SERVICE BULLETIN

* Supersedes Service Bulletin SB900-116, dated 24 February 2010. Revised to change the inspection interval for the blade retention bolt force and torque check following the first flight after installation from 4 to 6 flight-hours to 8 to 10 flight-hours; and to revise the change of force or torque from not more than 10 percent to not more than ± 10 percent.

300-HOUR INSPECTION FOR THE MAIN ROTOR BLADE RETENTION BOLTS

SB900-116R1 – 300-HOUR INSPECTION FOR THE MAIN ROTOR BLADE RETENTION BOLTS

Figure 1. Gap and Force Check of the Blade Retention Bolts

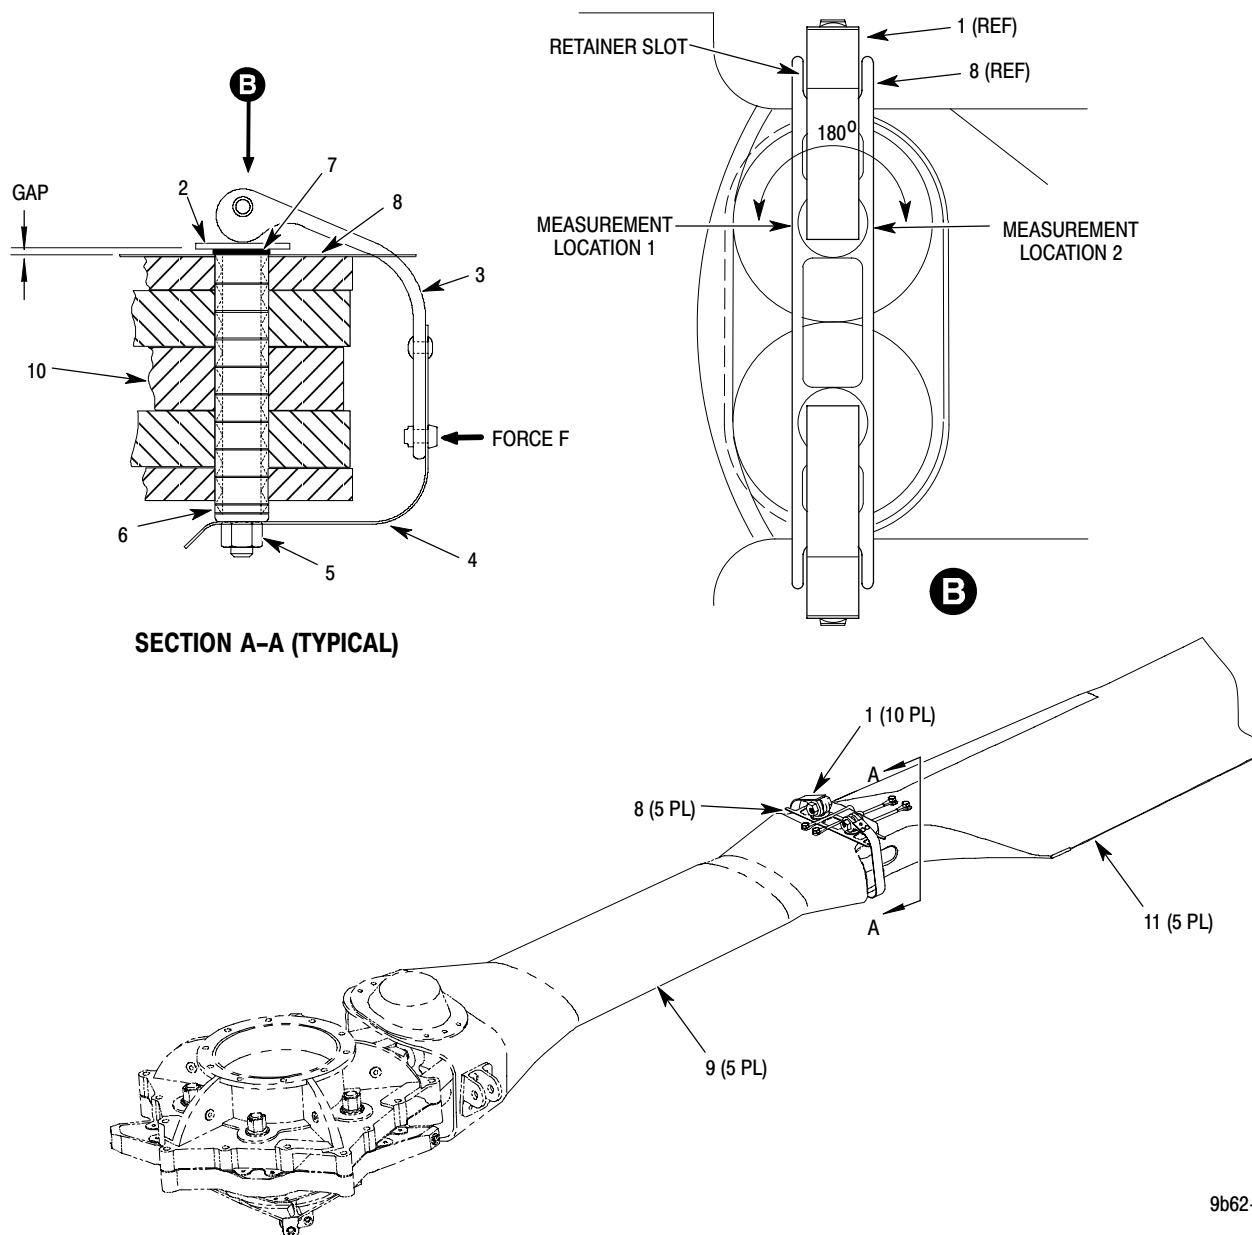
- (1). Visually examine blade retention bolts (1) for a gap between thrust washer (2, 4) and retainer (8, 9). (Ref. Figure 1 and Figure 2.)
 - (a). Make sure O-ring (7) is installed.

- 1). Install missing O-rings (ref. CSP-900RMM-2, 62-10-00, Main Rotor Blade Removal/Installation).
 - (b). If there is a gap go to Step (2).
 - (c). If there is no gap, remove blade retention bolt (1) (ref. CSP-900RMM-2, 62-10-00, Main Rotor Blade Removal/Installation).

- (2). Measure the gap at two locations, 180 degrees apart, with a feeler gage.
 - (a). If the gap is more than **0.100 inch (2.54 mm)** remove blade retention bolt (1) (ref. CSP-900RMM-2, 62-10-00, Main Rotor Blade Removal/Installation).

- (5). Do a check of Force F with a push/pull spring scale.

- (a). If Force F has changed by more than ± 10 percent of the recorded final installation force, turn hex nut (5) until the Force F required to close cam handle (3) is **65 to 115 lbf (29.48 to 52.16 kgf)**.
- (b). If necessary, turn hex nut (5), in the tightening direction only, to align the nut with the hex-shaped hole of spring clip (4) without a recheck of Force F.

(1). Examine the position of blade retention bolts for up or down movement (ref. Figure 1).

Figure 2. Gap and Torque Check of the Blade Retention Bolts

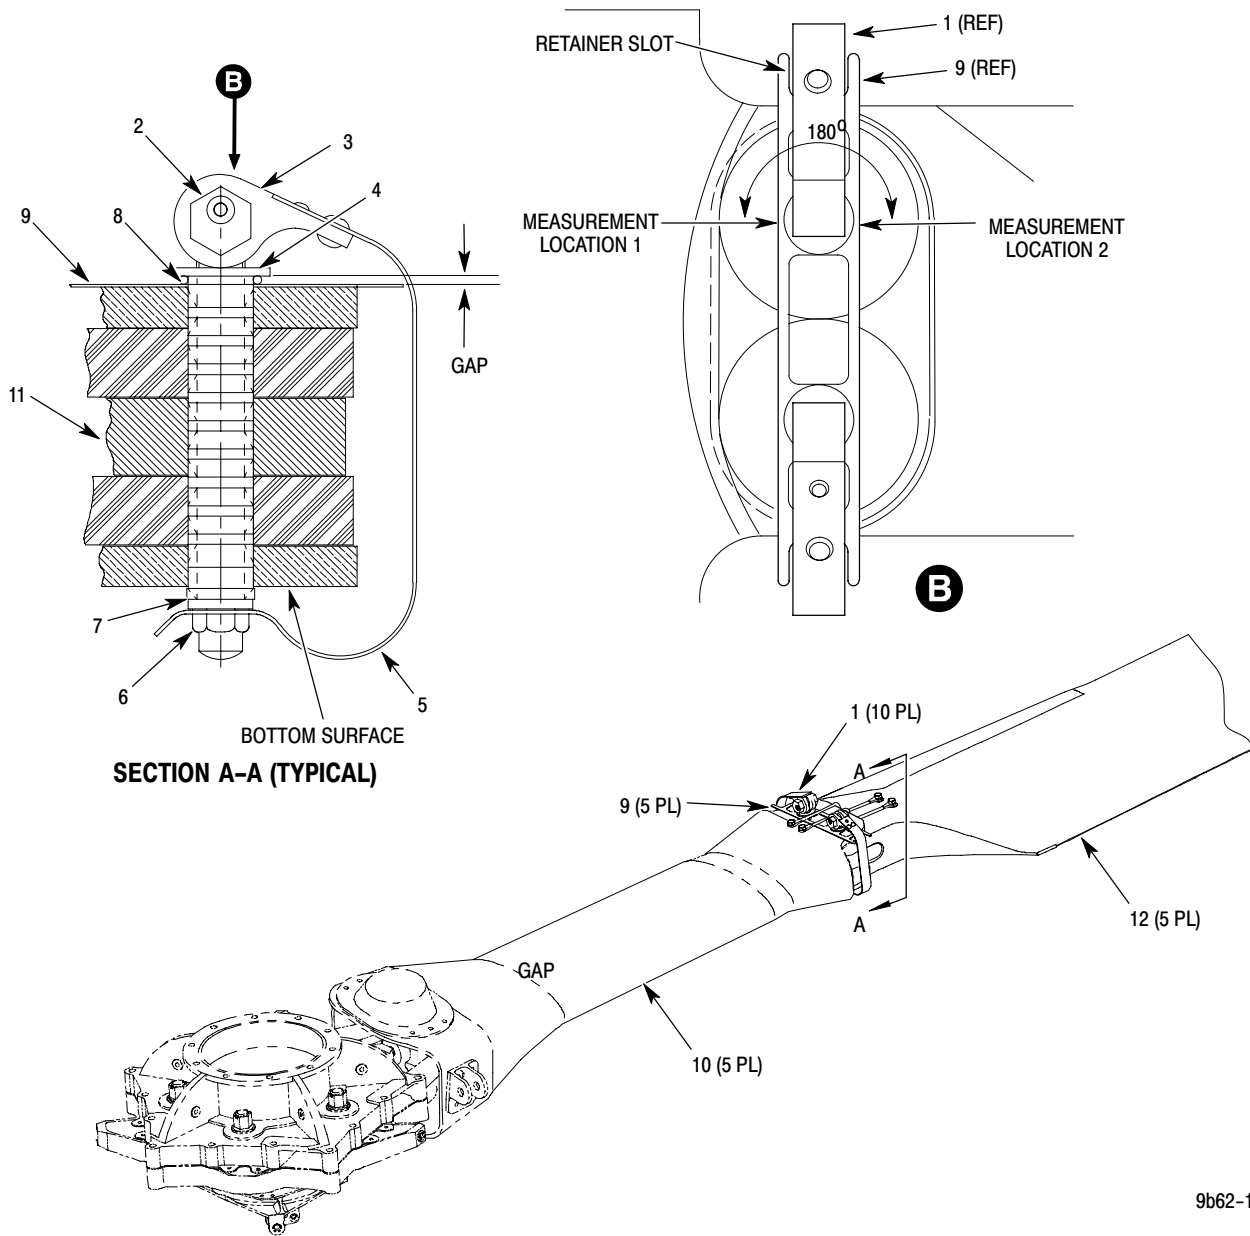
- (1). Release the collective friction to remove the preload of the flexbeams (ref. CSP-900RMM-2, 67-10-00, Rotor Flight Controls Removal/Installation).
 - (a). Apply electrical power with ground power unit (T2002) (ref. CSP-900RMM-3, 96-00-00, Electrical Power Maintenance Practices, Helicopter Electrical Power).
 - (b). Push the collective friction release switch forward to release the collective friction.
 - (c). Raise the pilot collective stick sufficiently to unload the collective controls (approximately 15 to 30 percent indication on the IIDS).
 - (d). Remove electrical power (ref. CSP-900RMM-3, 96-00-00, Electrical Power Maintenance Practices, Helicopter Electrical Power).
- (2). Support main rotor blade (12) in line with the angle of pitchcase (9). (Ref. Figure 2).

(5). Do a torque check of torque nut (2).

(a). If the torque has changed by more than ± 10 percent of the recorded final installation torque (ref. CSP-900RMM-2, 62-10-00, Main Rotor Blade Removal/Installation), turn torque nut (2) until the torque required to close spring clip (5) is **350 to 450 in-lb (39.5 to 50.8 Nm)**.

(10). Make sure the gap between thrust washer (4) and retainer (9) is not more than **0.100 inch (2.54 mm)**.
